UNIVERSITY OF VIRGINIA
NUCLEAR REACTOR FACILITY

December 19, 2000
Docket No. 50-62, License R-66

Subject: UNIVERSITY OF VIRGINIA – REQUEST FOR ADDITIONAL INFORMATION
RE: DECOMMISSIONING AMENDMENT REQUEST (TAC NO. MA8186).

**UVA RESPONSE TO NRC REQUEST FOR ADDITIONAL INFORMATION
UNIVERSITY OF VIRGINIA RESEARCH REACTOR
DOCKET NO.50-62**

Figure 1. Known presence of Threatened and Endangered Animal Species.

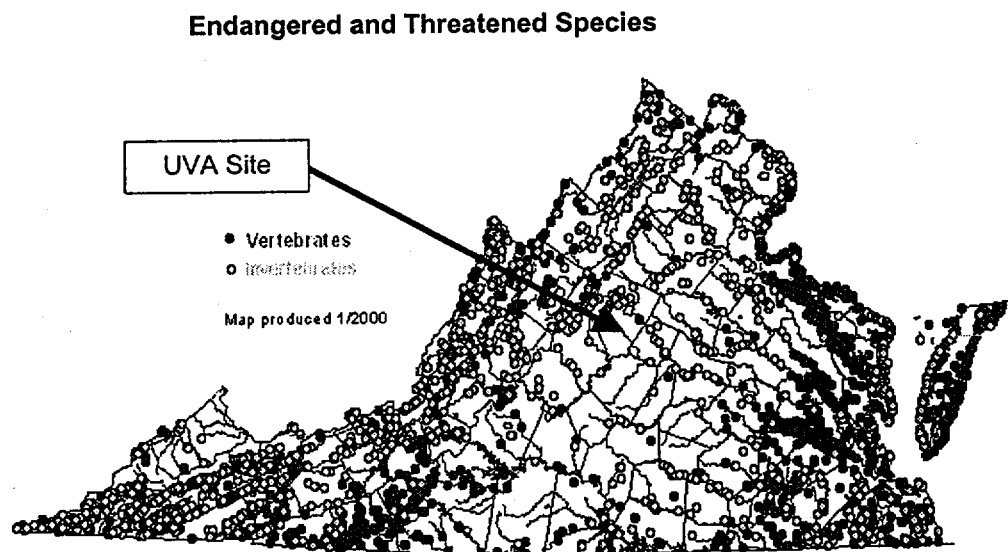
38. Environmental Report, Section 3.2.4, "Biology," Page B-26. Are there any endangered or threatened Federal or State species on site? What is the basis for your conclusion?

There are no known endangered and threatened plant or animal species at the UVA Reactor site. The Virginia Department of Conservation and Recreation's (DCR) database on endangered and threatened species was accessed to make this determination. We also consulted the Virginia Natural Heritage Program home-page on the world-wide web.
